Re: **INDIAN RIVER SCHOOL DISTRICT CLASSROOM ANNEX BUILDINGS**
Georgetown, Millsboro, and Selbyville Delaware
2013055.00, .01, .02, .03

ADDENDUM ONE

The contract documents for the above referenced project, Project Manual, dated June 11, 2013 and Drawings, dated June 10, 2013, are amended as follows:

C-201

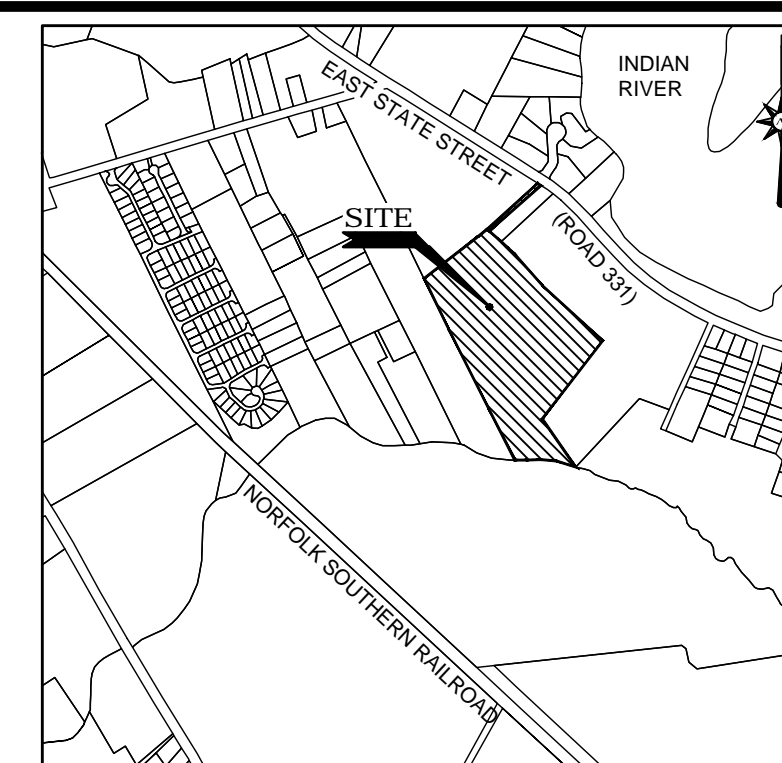
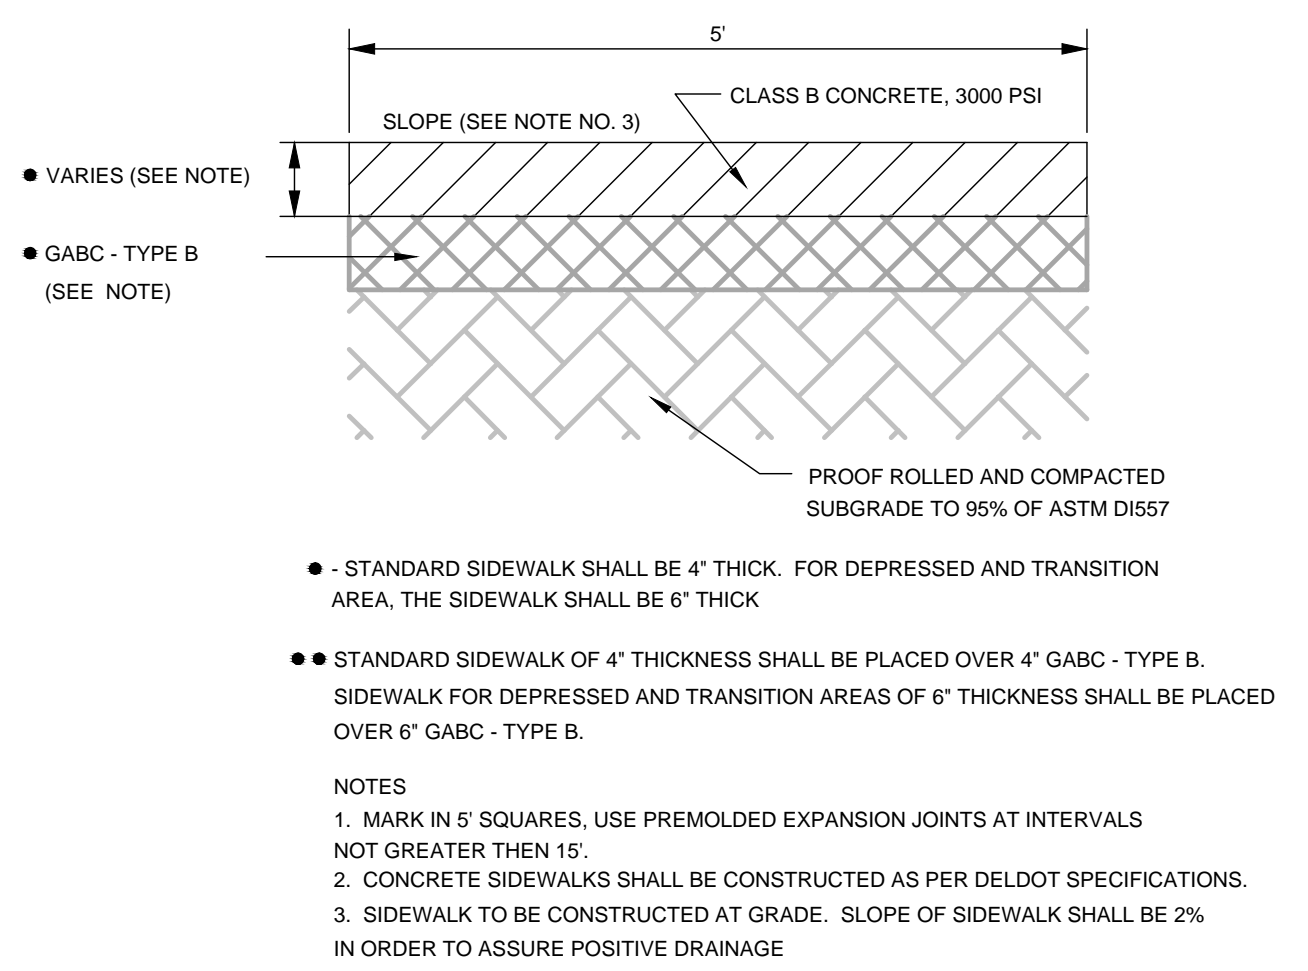
- 1. C-201 OVERALL PLAN (East Millsboro Elementary)
 - a. ADD Drawing issued via this addendum.
- 2. A100 ARCHITECTURAL SITE PLANS AND ACCESSIBLE TOILET ROOM RENOVATION AT NORTH GEORGETOWN AND LONG NECK
 - a. Detail 1: ADD replacement of drinking fountain and chase, per SKA-01.
 - b. Detail 3A:
 - i. REVISE note from "NEW DOOR AND FRAME" to "NEW DOOR AND FRAME, W/ (2) L4x3-1/2x5/16 LINTELS, 8" BRG.; PATCH FLOOR TILE WITH WHOLE UNITS AS REQ'D, AND PROVIDE NEW MARBLE THRESHOLD".
 - ii. REVISE note from "NEW CMU" to "NEW CMU, W/ CT FIN TO MATCH EXG TLT RM".
 - iii. ADD note at vestibule outside toilet room as follows: "REPAINT WALL TO MATCH EXISTING, CORNER TO CORNER."
 - c. Detail 4: ADD replacement of drinking fountain and chase, per SKA-02, and stair and ramp work per SKA-03.
 - d. ADD Plumbing Fixture Notes, as follows:

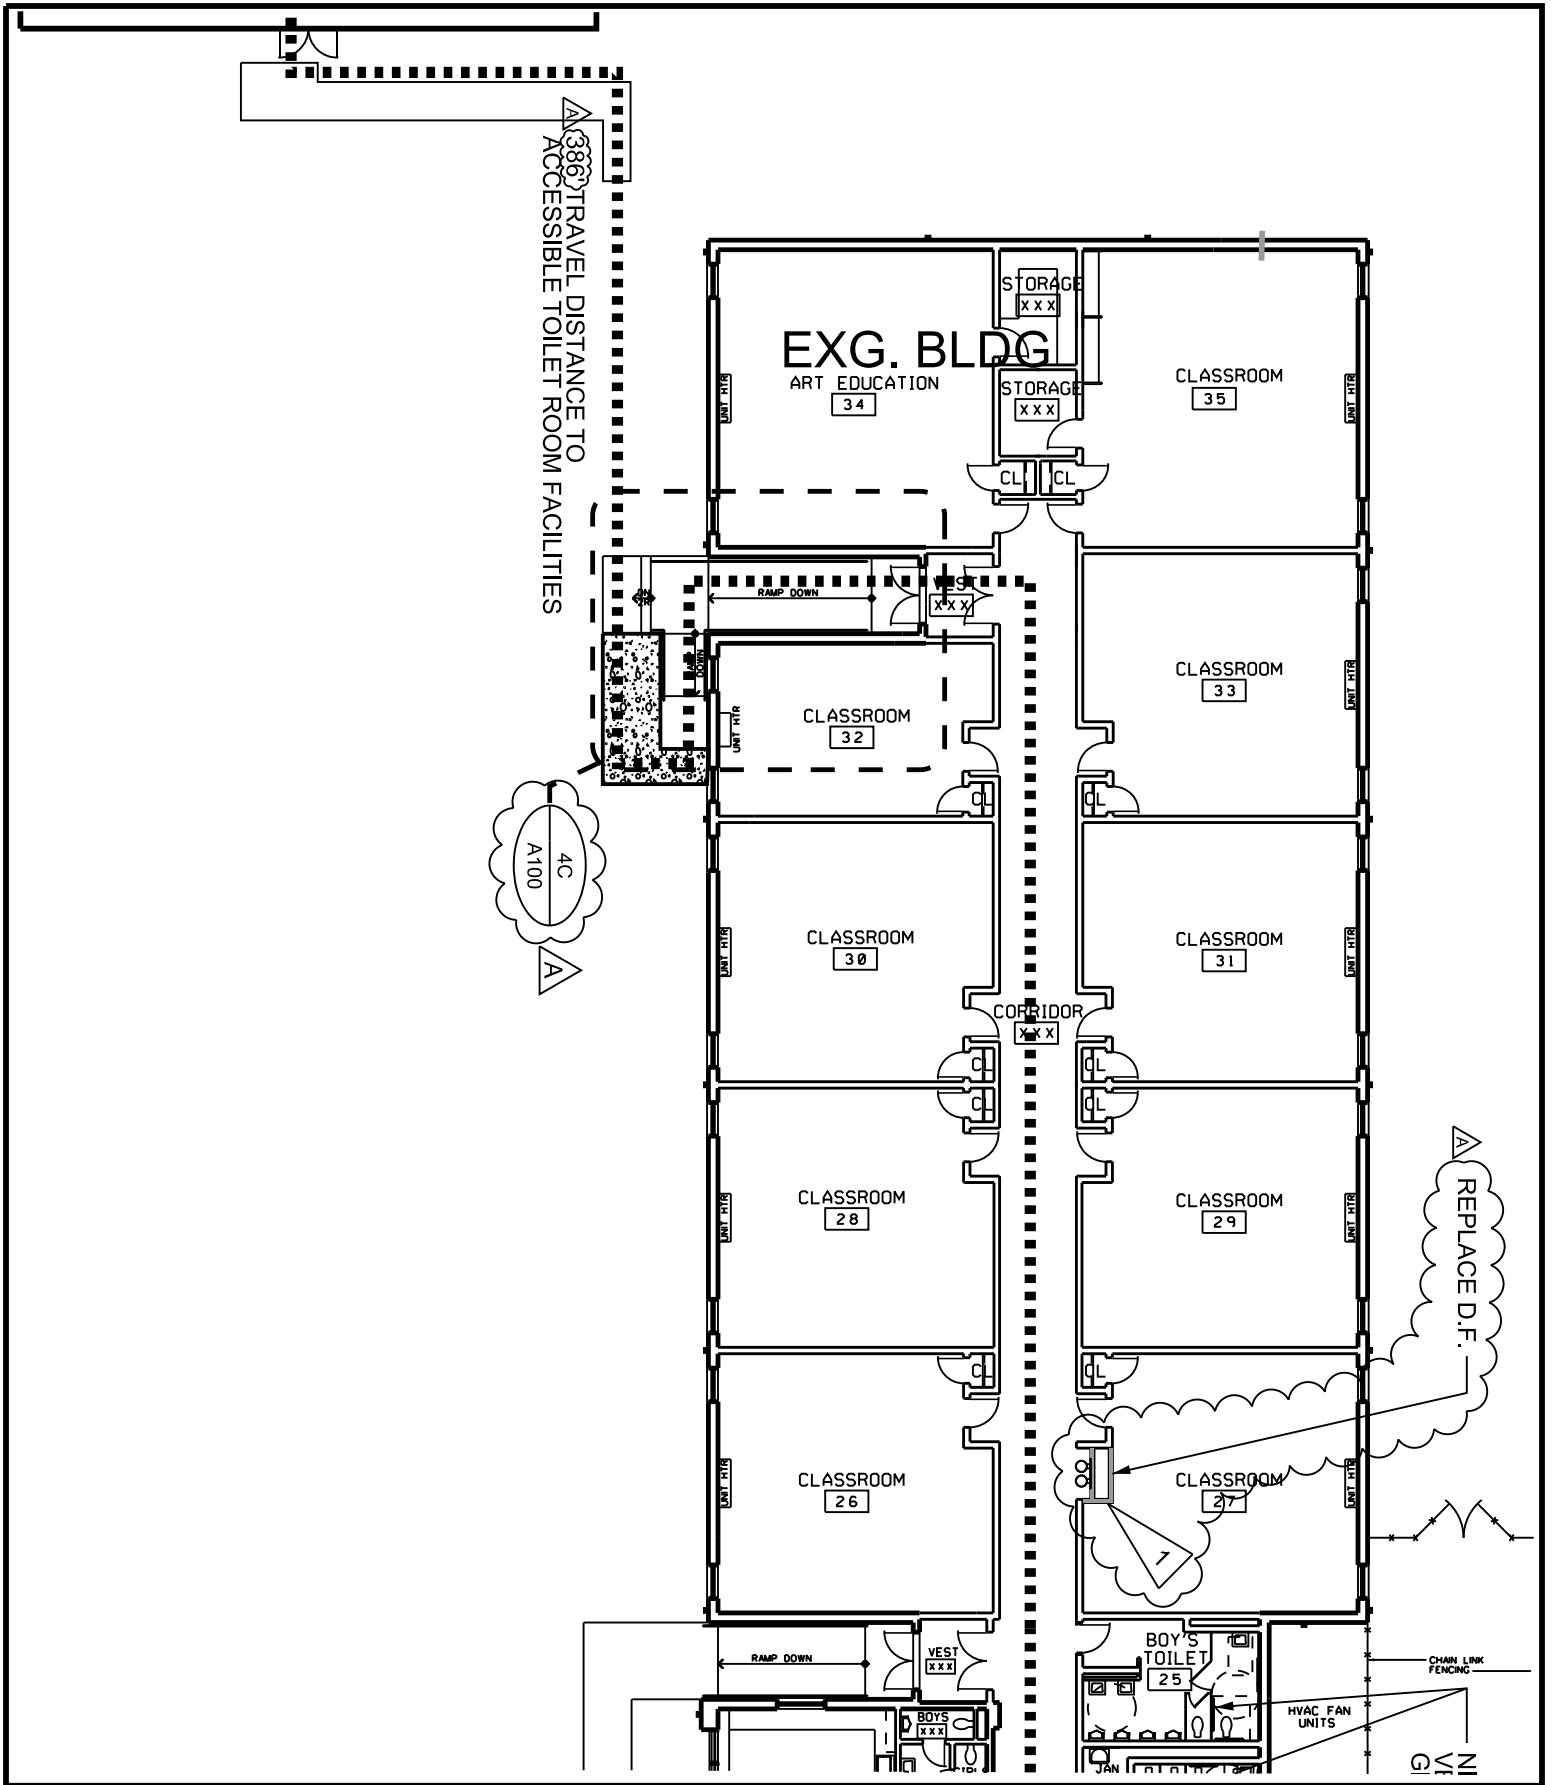
1 REMOVE EXG. DRINKING FOUNTAIN AND INSTALL NEW BI-LEVEL ADA-COMPLIANT WALL-MOUNTED DRINKING FOUNTAIN, CHASE WALLS TO MATCH EXG. ADJA CONSTRUCTION, REPAINT TO NEAREST CORNER. CONNECT NEW 1/2" COLD WATER, 1-1/4" SANITARY, AND 1-1/2" VENT TO EXG. SERVICES. NEW D.F. BASIS-OF-DESIGN HAWS COMPANY MODEL # 1011 BI-LEVEL DRINKING FOUNTAIN W/ 18GA 304 SST CONSTRUCTION AND LEAD-FREE WATERWAYS; UNIT SHALL BE PROVIDED W/ NECESSARY EQPT FOR ADA INSTALLATION BY D.F. MFR.
